Re: Item No. 12.1

Case 22511

1144-1150 Barrington Street

3.3.1.D materials

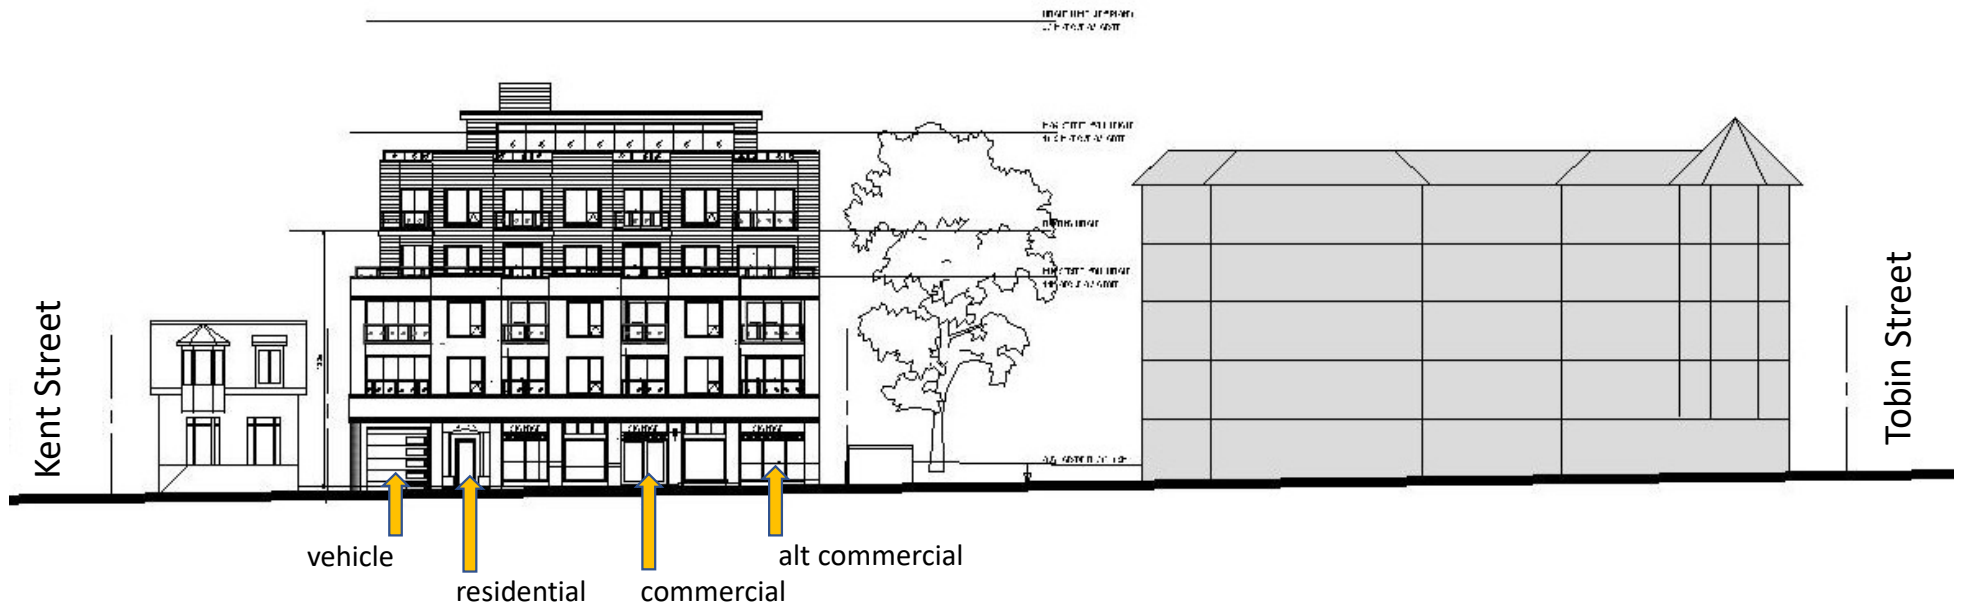
The Committee felt the overall building design is not consistent with the Design Manual with respect to prominent civic frontage, namely, more distinct articulation and architectural features to reinforce visual prominence and the historical nature of the site. The Committee further recommended that further consideration be given to sections 3.2.1A, 3.3.1D, 3.3.3A, 3.4.1B, 3.1.1C, 2.3.2 of the Design Manual and requested that the Architect attend the Committee meeting to respond to questions should the application return.
